**Regarding:** Block 1618, Lot 29  
441 Newark Pompton Turnpike Associates, Inc.  
Site Plan Storm Drainage Review

As requested, we reviewed the site plans for the above application prepared by Darmstatter, Inc., revised to September 8, 2021 consisting of seven sheets and offer the following comments on the drainage design:

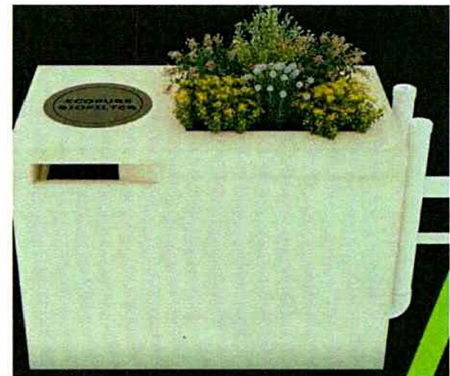
1. The site utilizes proprietary "EcoPure BioFilter" inlets which are composed of a curb opening, to a dual chamber entrapment basin with treatment soil. The treatment soil supports plants at the surface. Nine model sizes were approved by NJDEP for various treatment areas.

The NJDEP certifies the use of the <sup>TM</sup> stormwater treatment system at a TSS removal rate of 80% when designed, operated, and maintained in accordance with the information provided by the manufacturer.

Based on the contributory pavement areas to the four proposed catch basins, Model 8 x 20 is required. **This model size must be noted on the plans.**

The site design must be checked to ensure the required size devices **can be accommodated** without physical conflicts.

**The site design** must be checked to ensure that the treatment device outlet pipe can be connected to a 15" diameter pipe and aligned with the drain routes provided on the site plan i.e. can any connection be made to the unit from any direction?

The **maintenance and operation requirements** of the “EcoPure BioFilter” device must be provided on the site plans.

An “EcoPure BioFilter” does not appear necessary for Inlet B3 since no contributory area requires treatment.
